Notice of Allowability	Application No.	Applicant(s)	
	10/624,791	BENEDICT, GEORGE	
	Examiner	Art Unit	
	Patrick J. Lee	2878

EXAMINER'S AMENDMENT

FIGURE 13

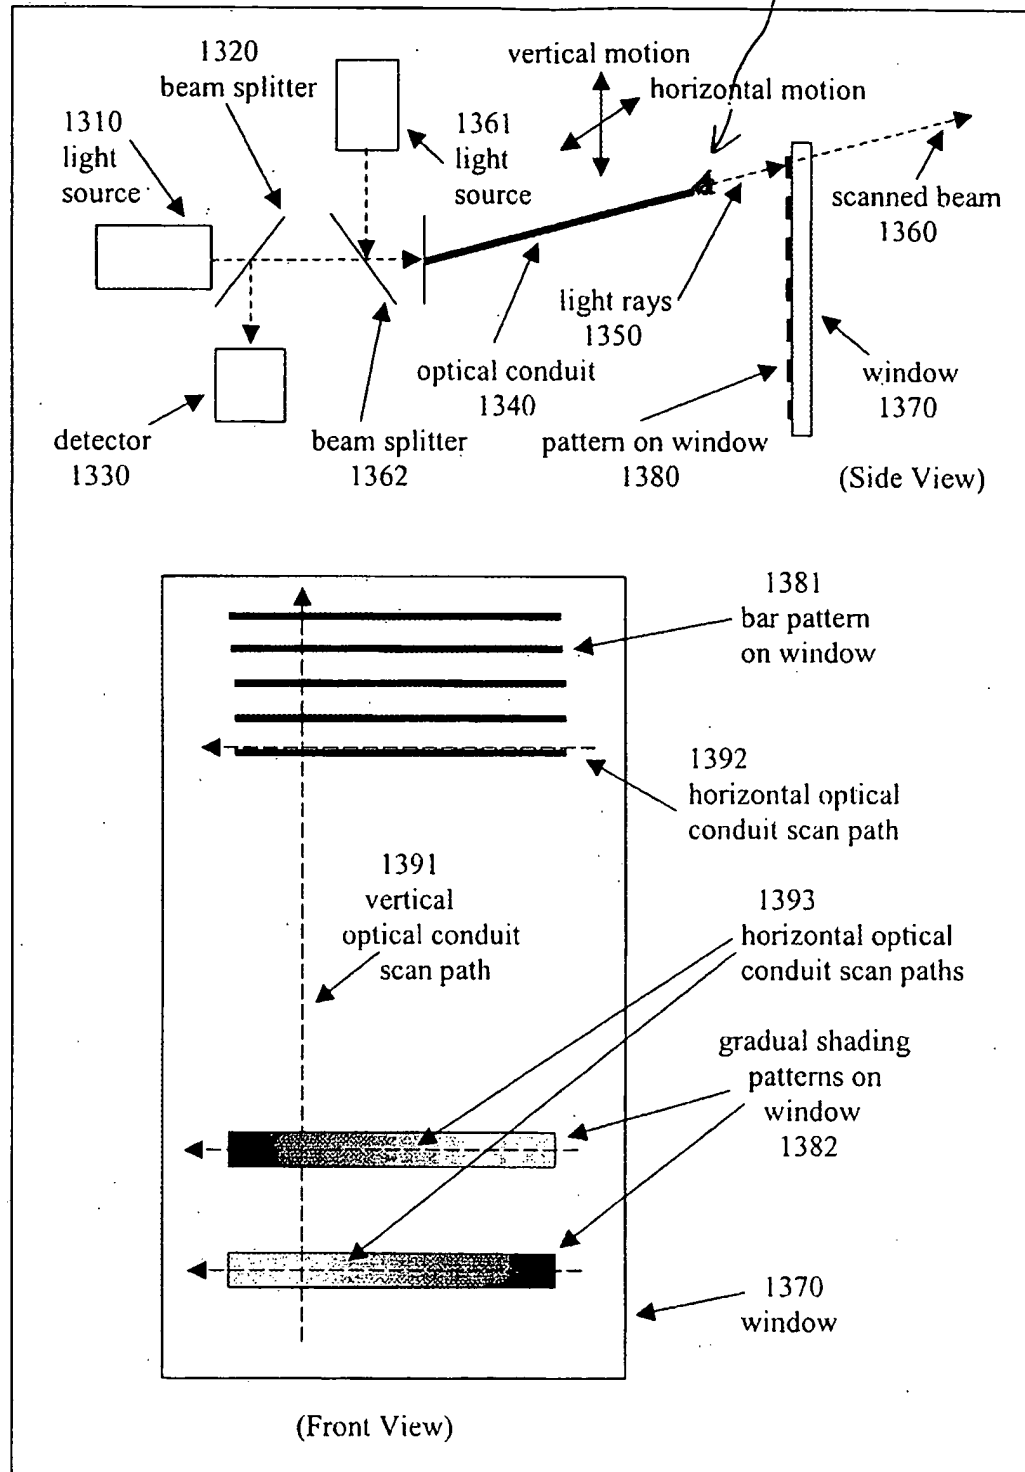
An arrowhead is added to light rays (1350) to show that the 2nd part of the light beam is sent to detector (1330) with encoded information about the position of the conduit.

In order to avoid abandonment of the application, applicant must make these above agreed upon drawing changes.
